MOD2020/0049

SCHEDULE OF MODIFICATIONS SOUGHT

PROJECT ADDRESS
98 CUTLER ROAD,
CLONTARF

CLIENT
BOWES HOUSE

04 - Level 4

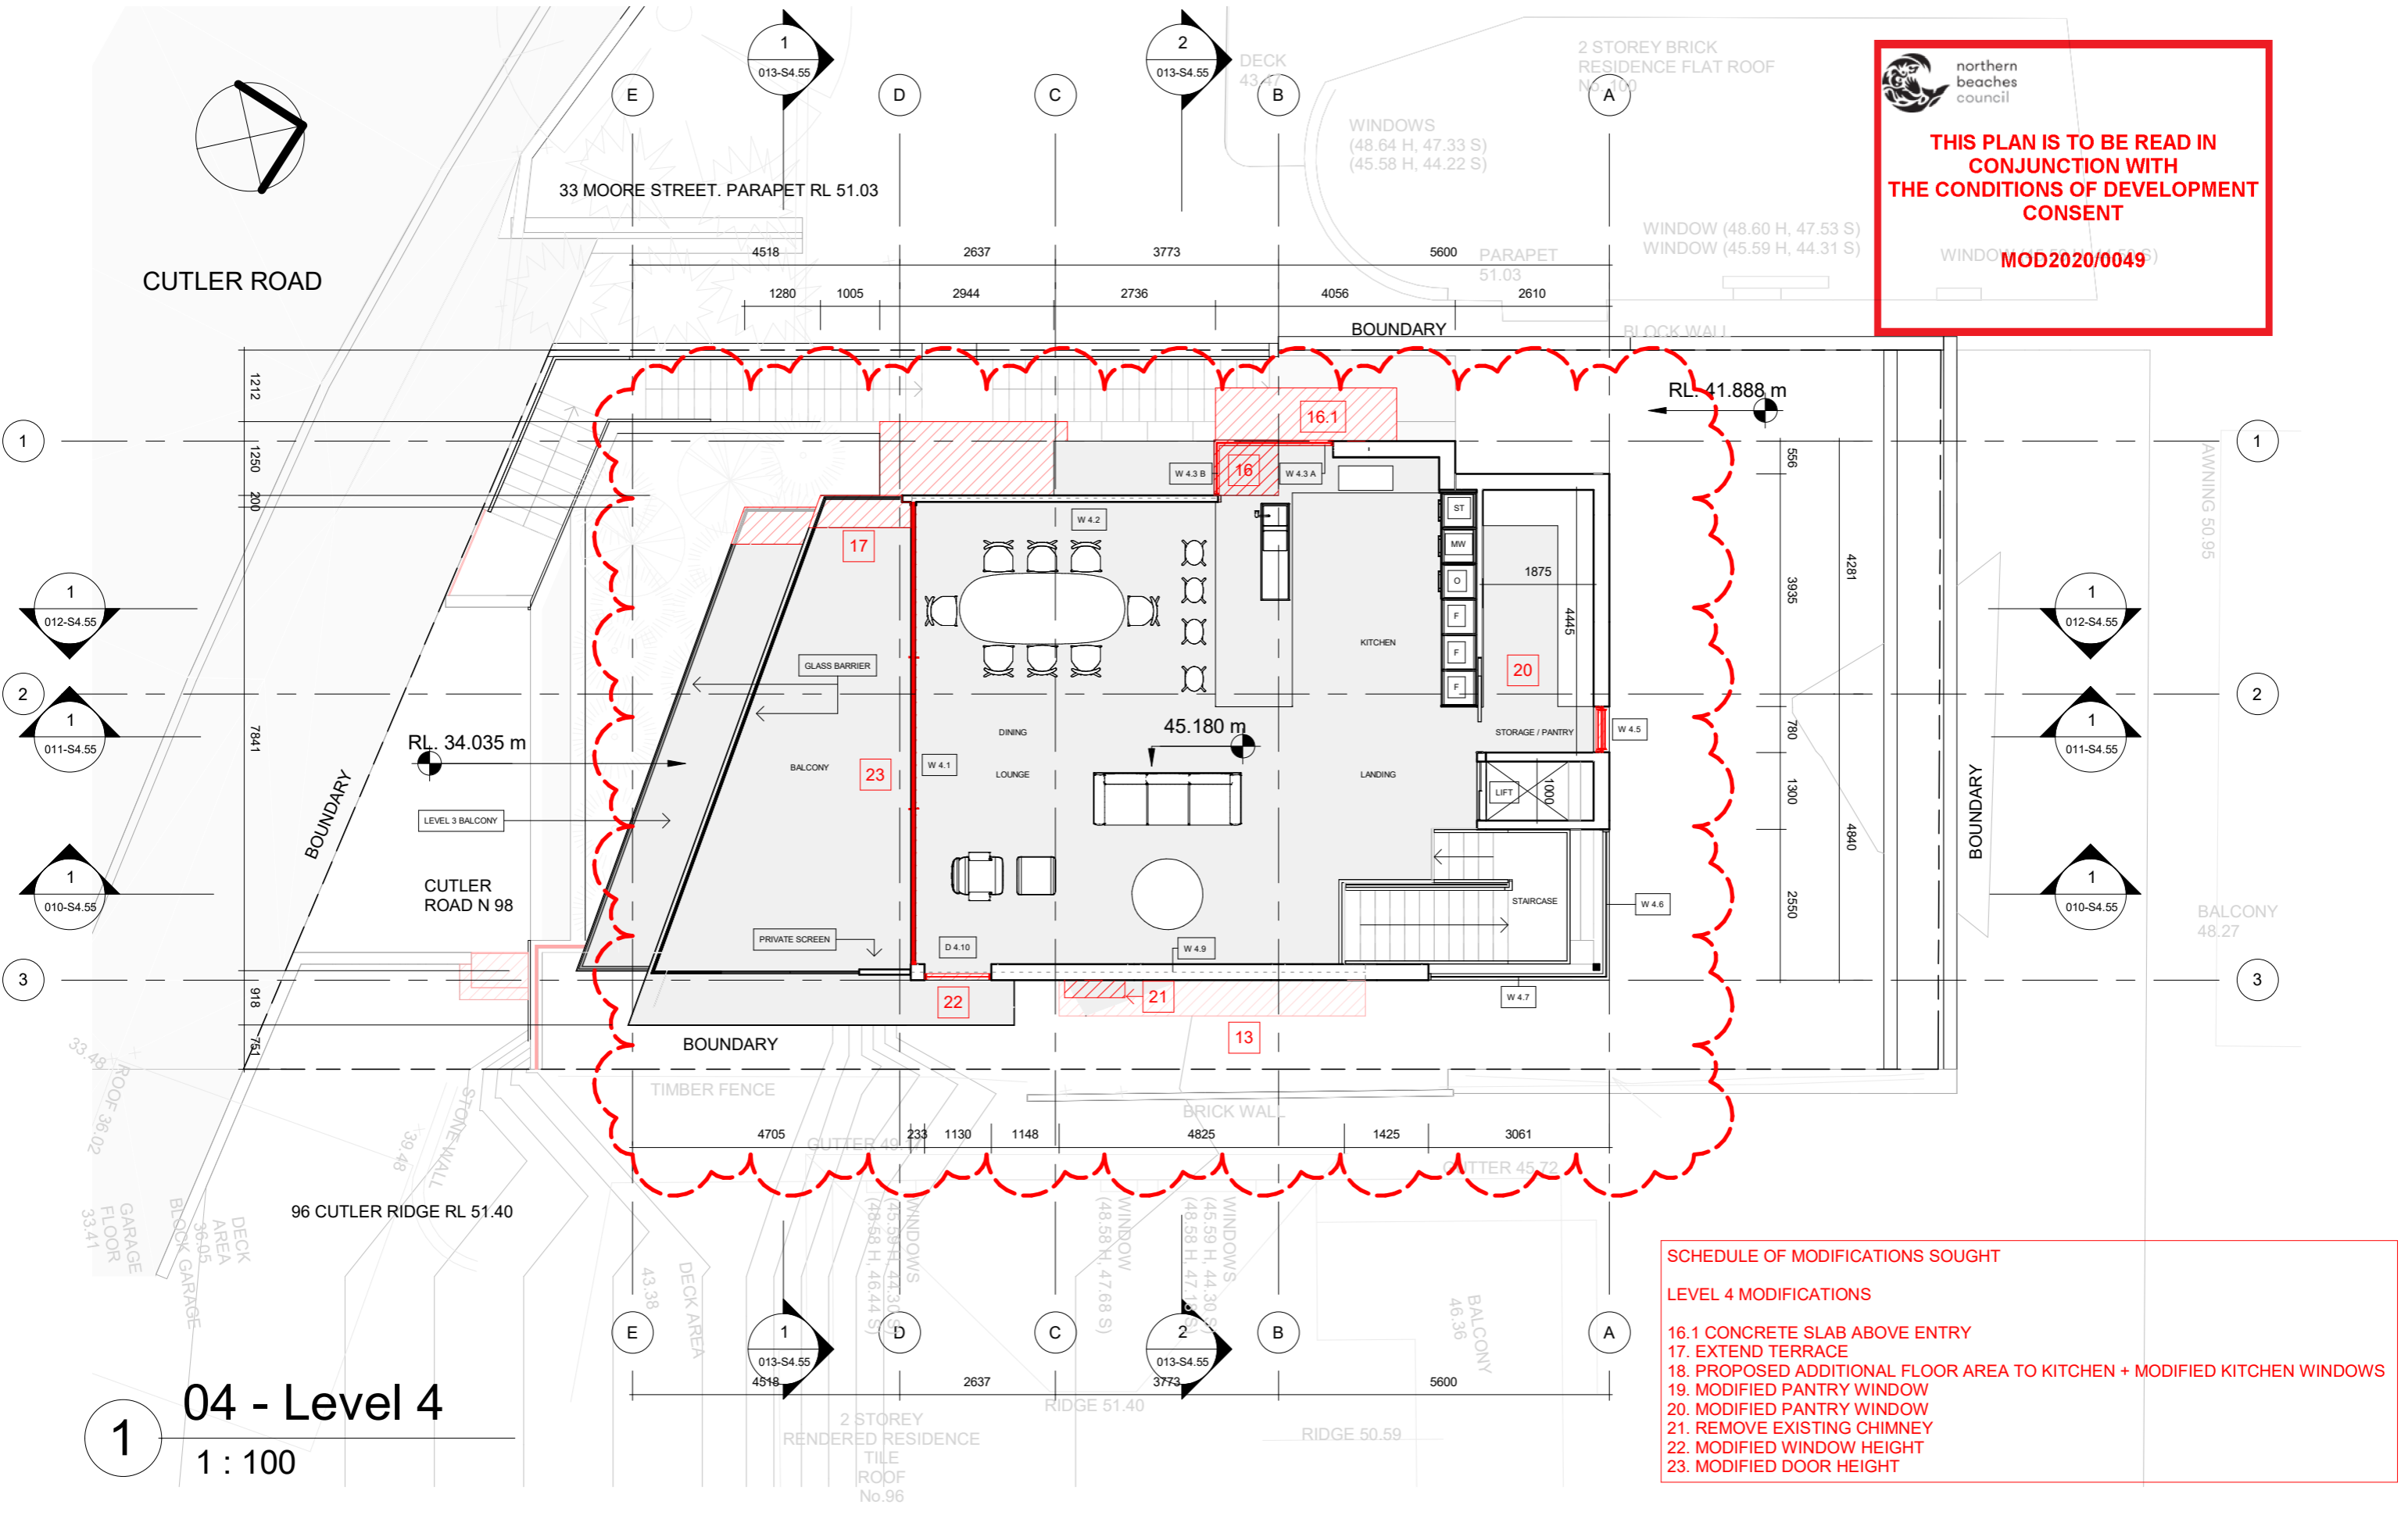
- SCHEDULE OF MODIFICATIONS SOUGHT**
- LEVEL 4 MODIFICATIONS**
- 16.1 CONCRETE SLAB ABOVE ENTRY
 - 17. EXTEND TERRACE
 - 18. PROPOSED ADDITIONAL FLOOR AREA TO KITCHEN + MODIFIED KITCHEN WINDOWS
 - 19. MODIFIED PANTRY WINDOW
 - 20. MODIFIED PANTRY WINDOW
 - 21. REMOVE EXISTING CHIMNEY
 - 22. MODIFIED WINDOW HEIGHT
 - 23. MODIFIED DOOR HEIGHT

03 - Level 3
1 : 100

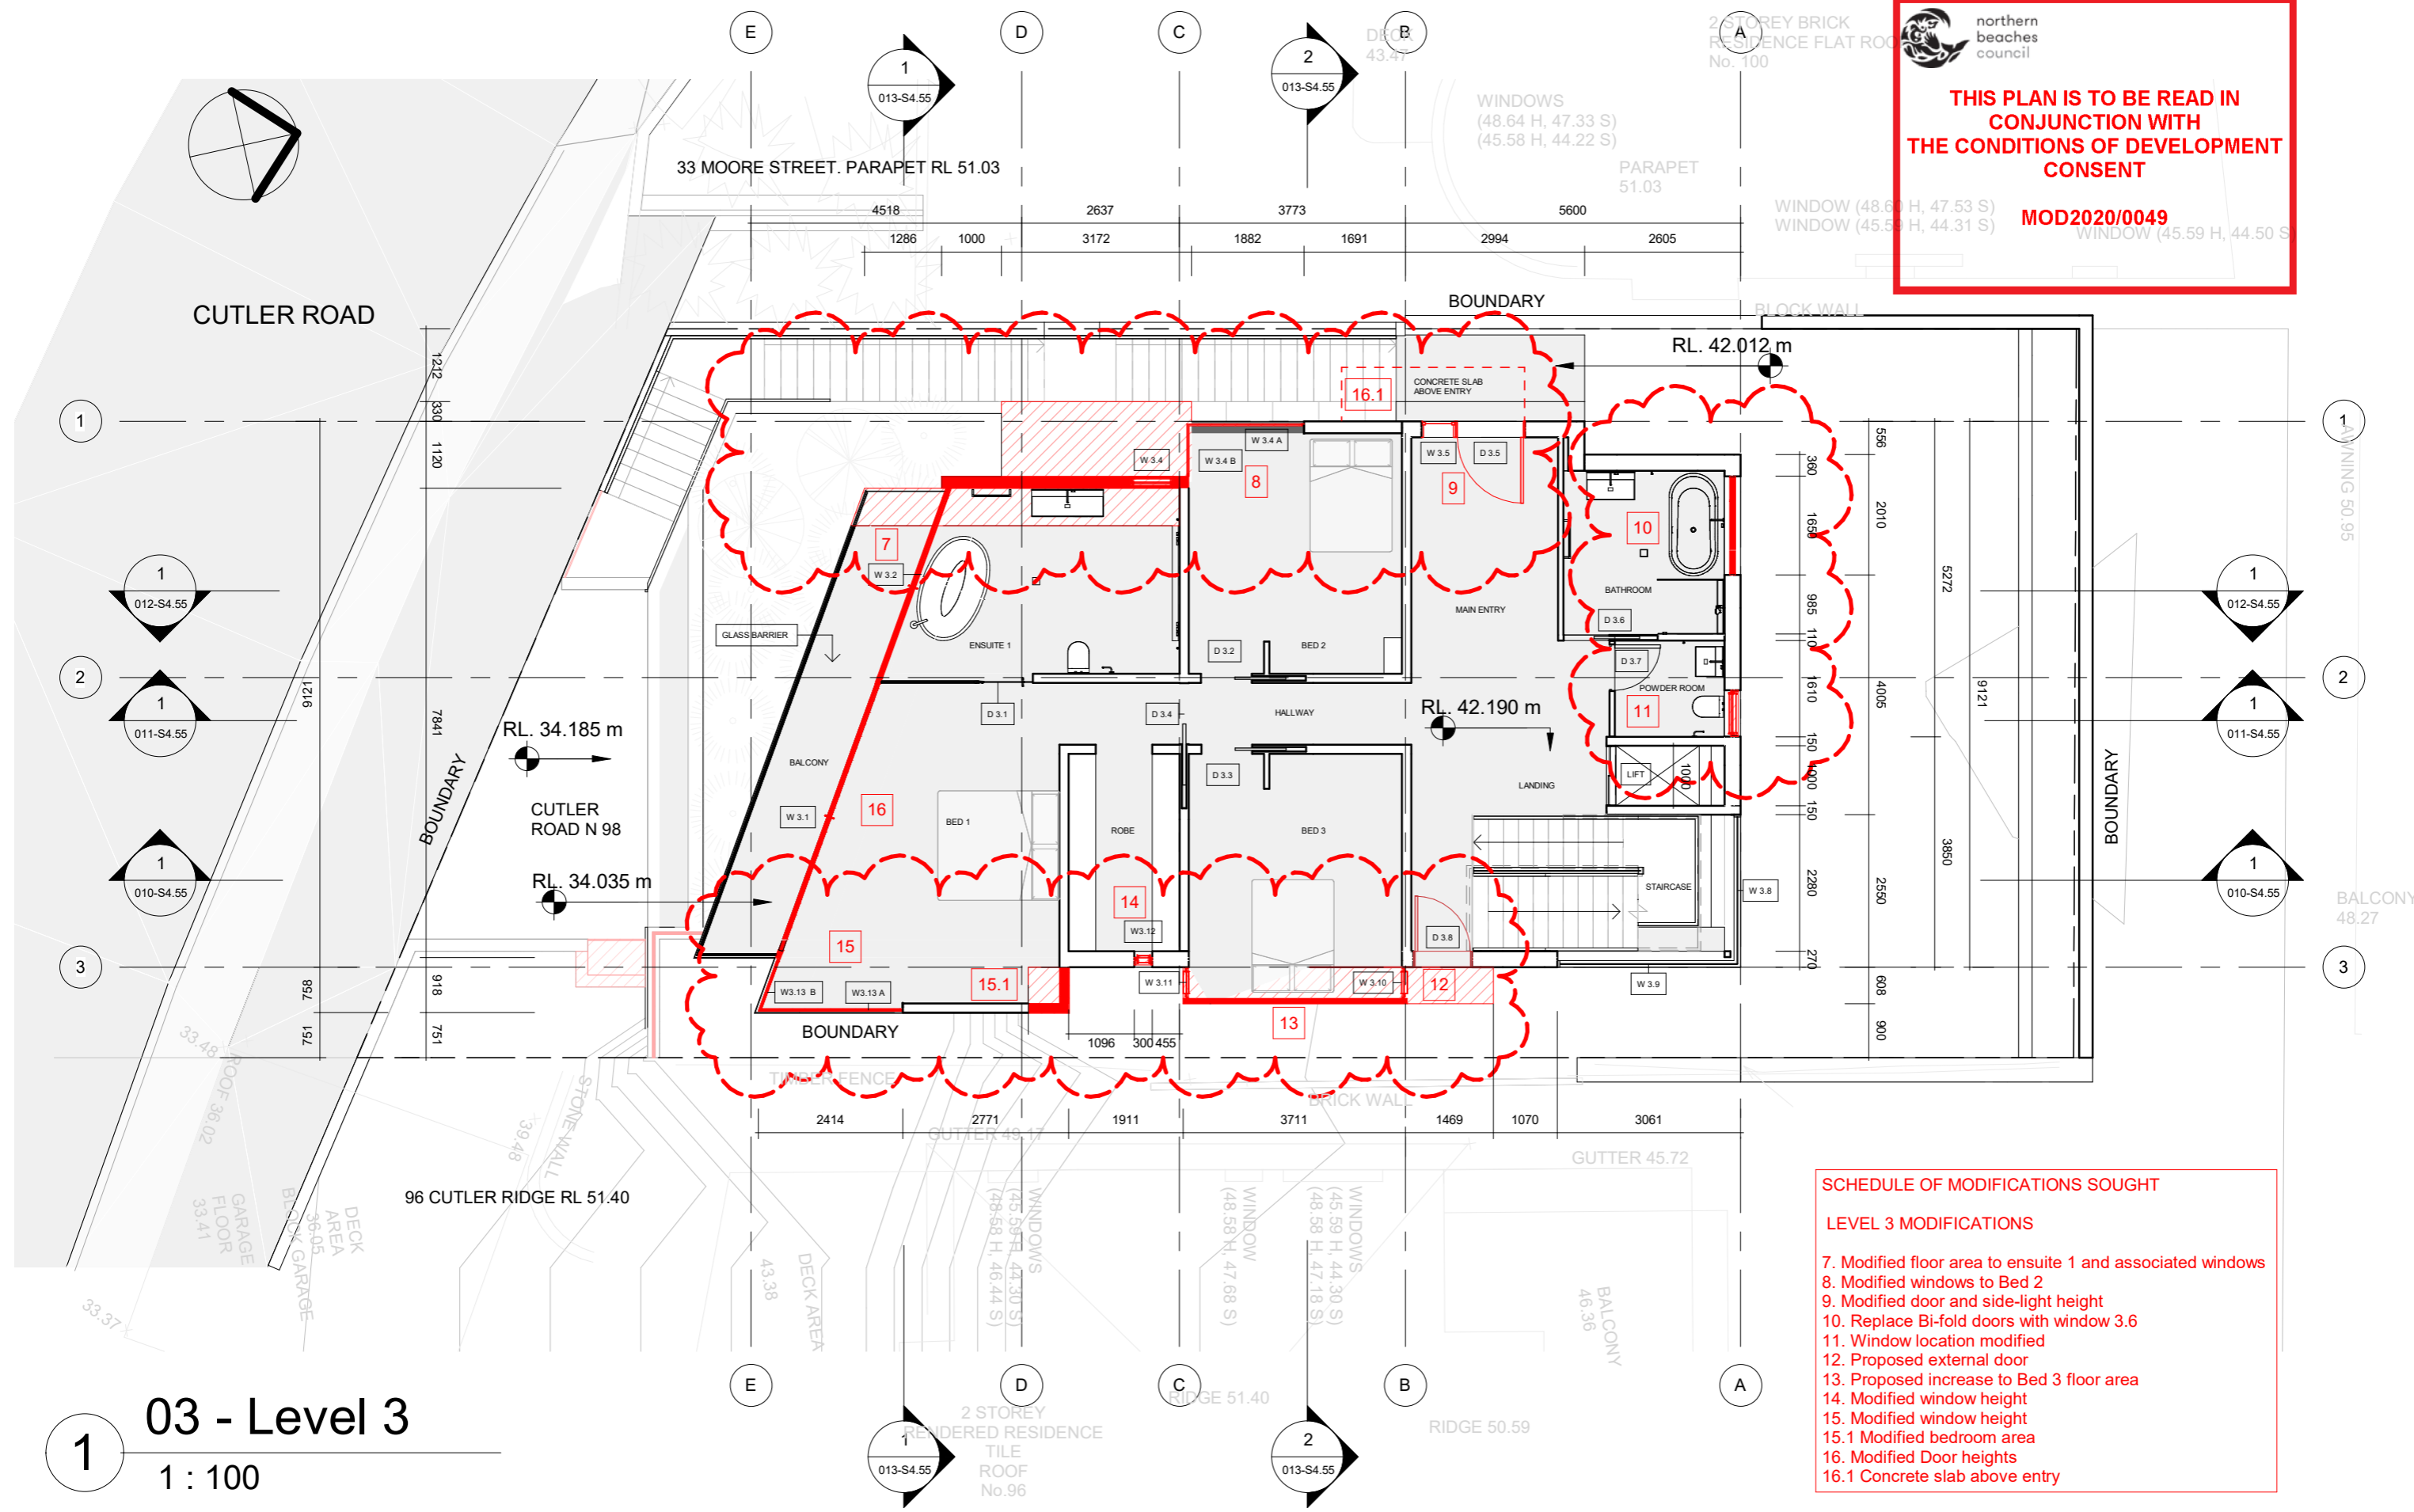
- SCHEDULE OF MODIFICATIONS SOUGHT**
- LEVEL 3 MODIFICATIONS**
- 7. Modified floor area to ensuite 1 and associated windows
 - 8. Modified windows to Bed 2
 - 9. Modified door and side-light height
 - 10. Replace Bi-fold doors with window 3.6
 - 11. Window location modified
 - 12. Proposed external door
 - 13. Proposed increase to Bed 3 floor area
 - 14. Modified window height
 - 15. Modified window height
 - 15.1 Modified bedroom area
 - 16. Modified Door heights
 - 16.1 Concrete slab above entry

02 - Level 2

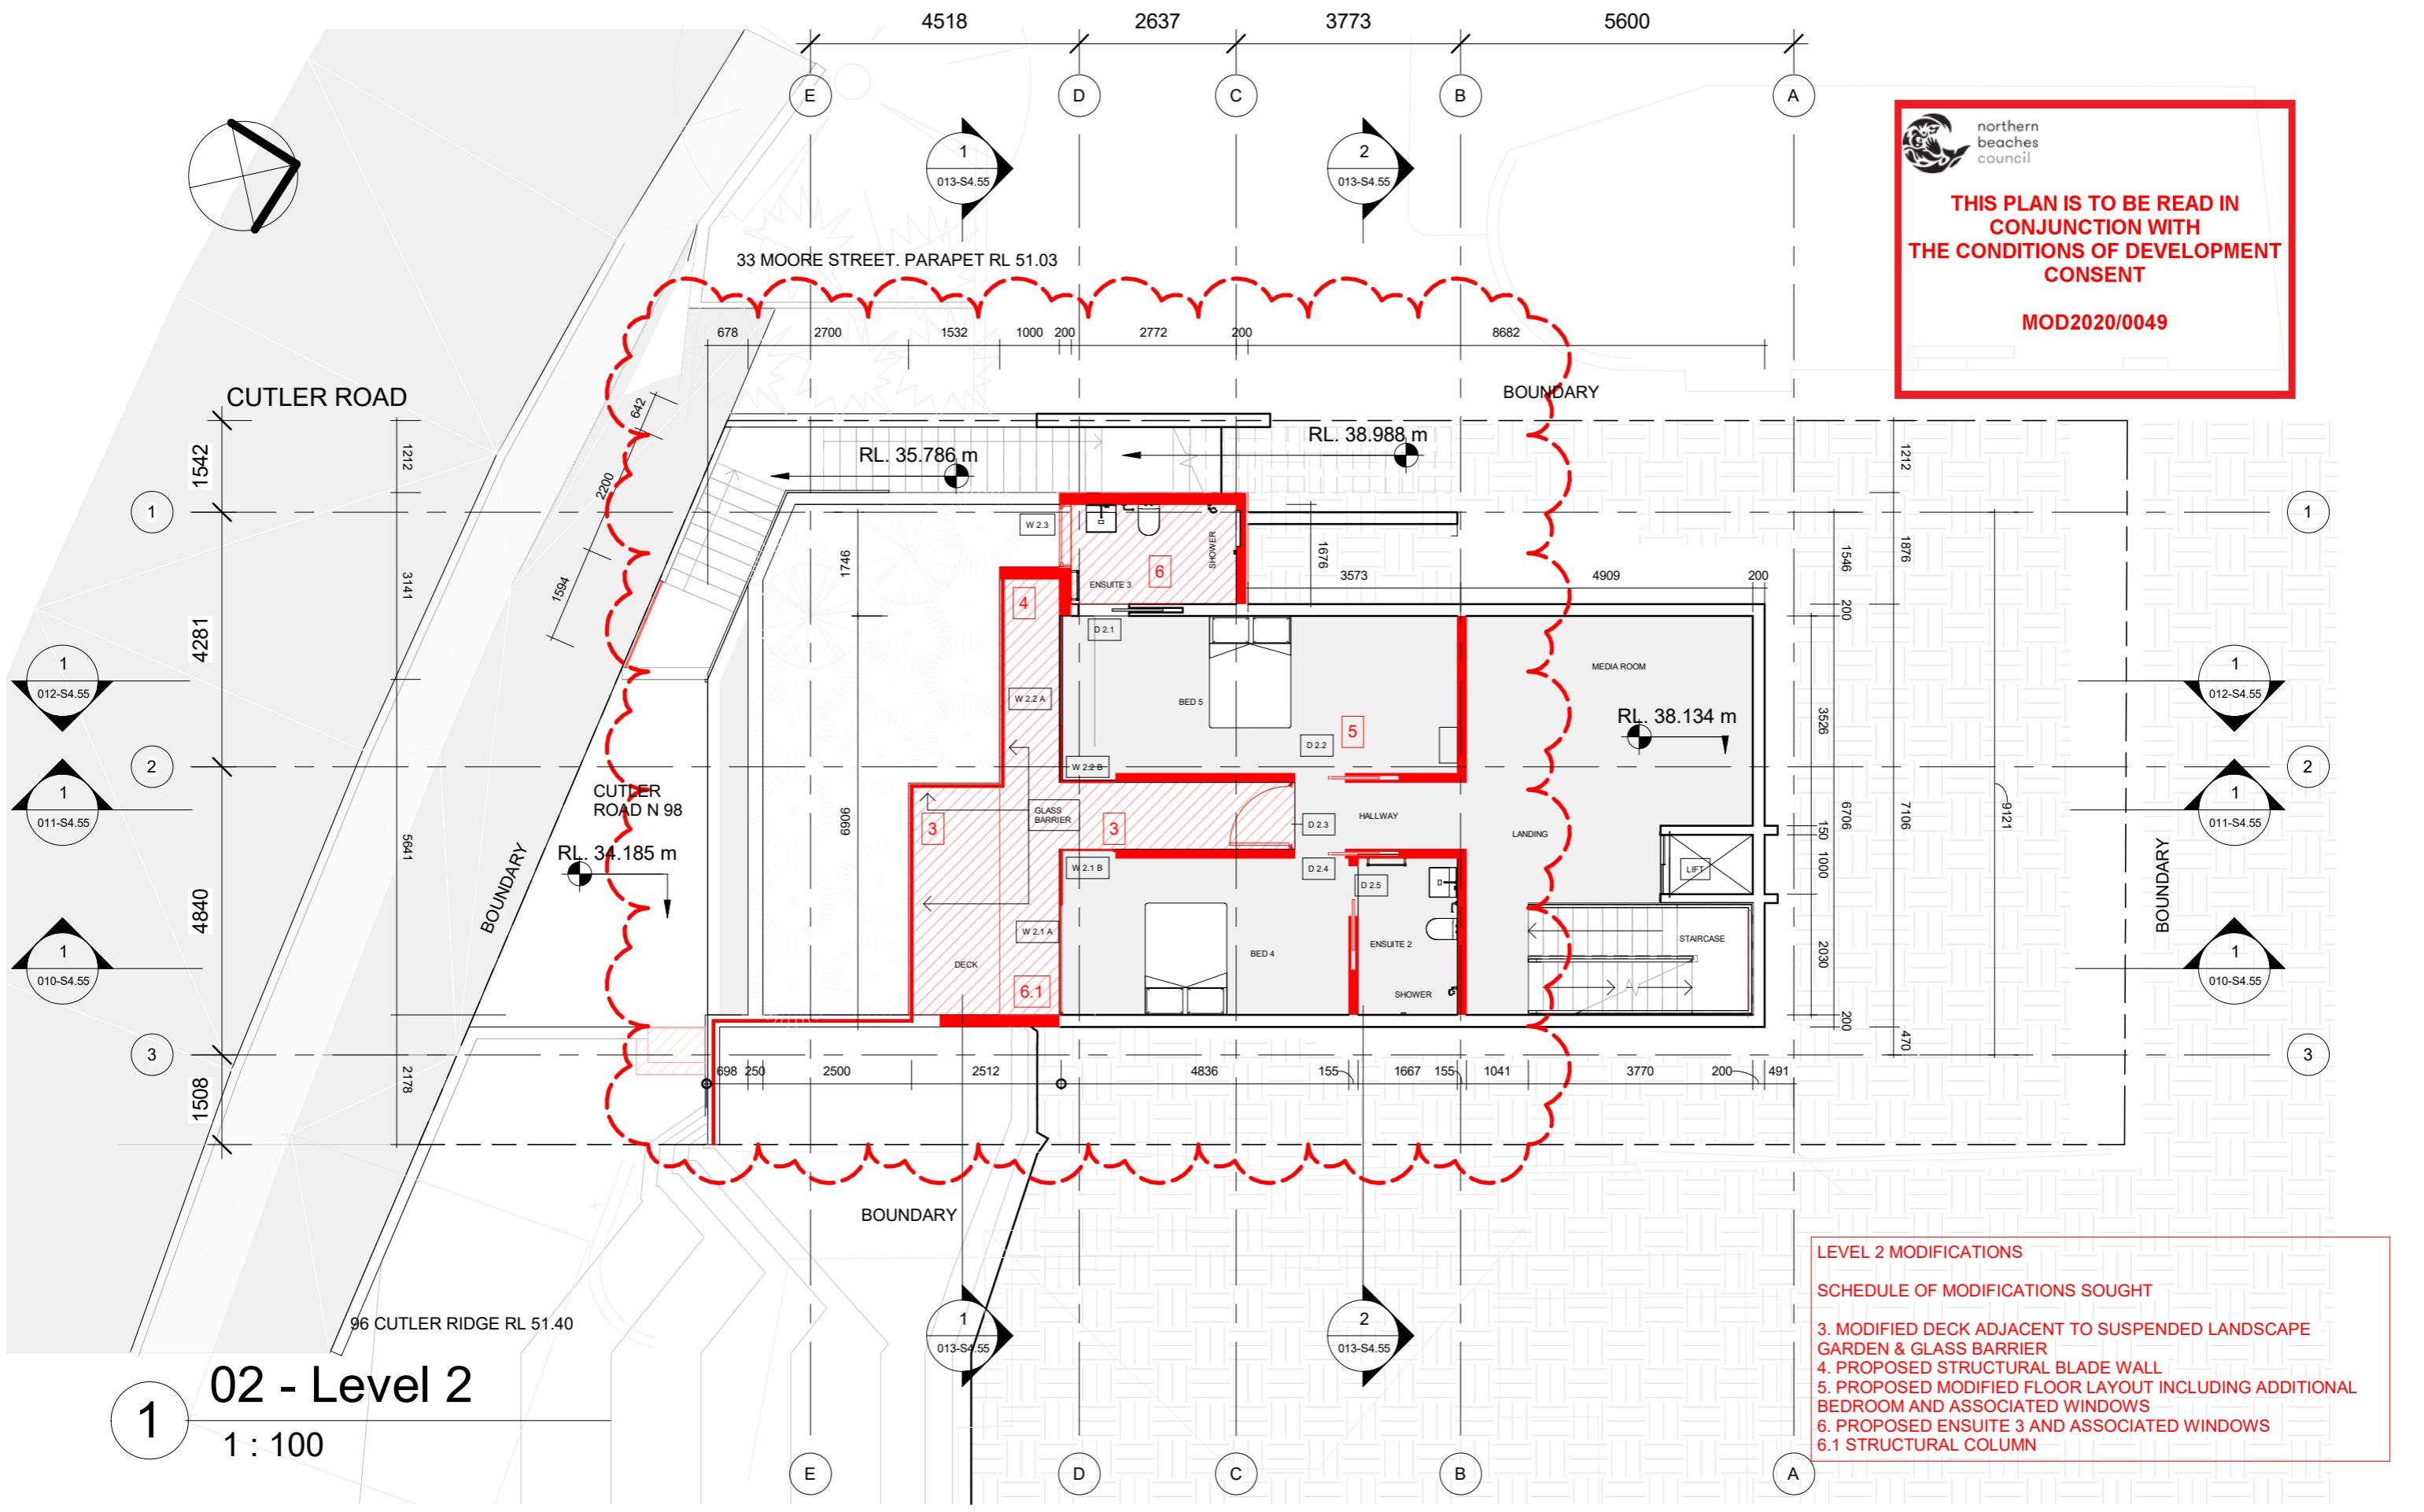
3. MODIFIED DECK ADJACENT TO SUSPENDED LANDSCAPE GARDEN & GLASS BARRIER

4. PROPOSED STRUCTURAL BLADE WALL

5. PROPOSED MODIFIED FLOOR LAYOUT INCLUDING ADDITIONAL BEDROOM AND ASSOCIATED WINDOWS

6. PROPOSED ENSUITE 3 AND ASSOCIATED WINDOWS

6.1 STRUCTURAL COLUMN
